Access Compliance Report

Public Rights-of-Way

Intersection ID: N/A	Main Street: ARBOR_LOOP_DR	Cross Street: POTOMAC_RIVER_PY	Location: SE
ADA ID: DCA5C6791E2B	Ramp Type: BlendTrans1	Initial Pass/Fail: Pass	Overall Compliance: No
Severity Score: 7.5			
Codes/Mitigation Info/Possible Solution		Field Measurements/Component Compliance

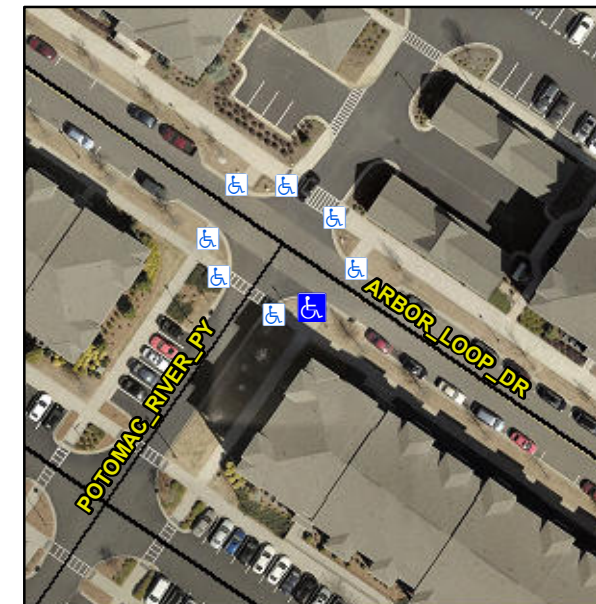
Not Found, R304.2.2-Perp, R304.3.2-Para, R305.1.4, R304.5.4

Compliance	Description	Data	Compliance	Description	Data
N/A	Ramp Length (in)	70.0	Yes	BlendTrans Slope (%)	2.6
Yes	Ramp Width (in)	83.0	Yes	BlendTrans XSlope (%)	0.3
Yes	Flare Type L	Curbed_NoWalkSurface	Yes	Flare Type R	Curbed_NoWalkSurface
N/A	Flare Slope LT (%)	N/A	N/A	Flare Slope RT (%)	N/A
N/A	Flare Traversable LT?	No	N/A	Flare Traversable RT?	No
Yes	Landing Length (in)	82.0	Yes	DWS Provided?	Yes
Yes	Landing Width (in)	84.0	Yes	DWS Contrast?	Yes
No	Landing Slope (%)	4.3	Yes	DWS Length (in)	24.0
Yes	Landing X Slope (%)	0.6	No	DWS Full Width?	No
N/A	Landing Curb? (Y/N)	No	Yes	DWS Offset (in)	0.0
N/A	Shared Landing?	No			
Yes	Gutter Ponding?	No	No	Gutter Slope (%)	5.3
Yes	Gutter Lip Ht (in)	0.0	Yes	Gutter X Slope (%)	0.3
N/A	Painted X Walk1?	No	N/A	Painted X Walk2?	N/A
	X Walk 1 Direction	To NE		X Walk 2 Direction	N/A
	X Walk 1 Width (in)	N/A		X Walk 2 Width (in)	N/A
	X Walk 1 Slope (%)	1.7		X Walk 2 Slope (%)	N/A

X Walk 1 X Slope (%)	0.6		X Walk 2 X Slope (%)	N/A
N/A	Ramp inside XWalk1?	N/A	N/A	Ramp inside XWalk2?	N/A
	Road Slope (%)	0.6		Clear Space?	Yes
	Road X Slope (%)	1.7	N/A	Clear Space to XWalk (in)	N/A
Yes	Any Obstructions?	No	Yes	Storm Grate/Utility Hazard?	No
	Obstruction Type			Storm Grate/Utility Type	
		N/A			N/A
			Yes	Surface Condition? (G/P)	Good
			No	Curb Slope (%)	5.4

Remove & Replace Curb Ramp With Two New Directional Ramps or Equivalent. Remove & Replace Gutter.
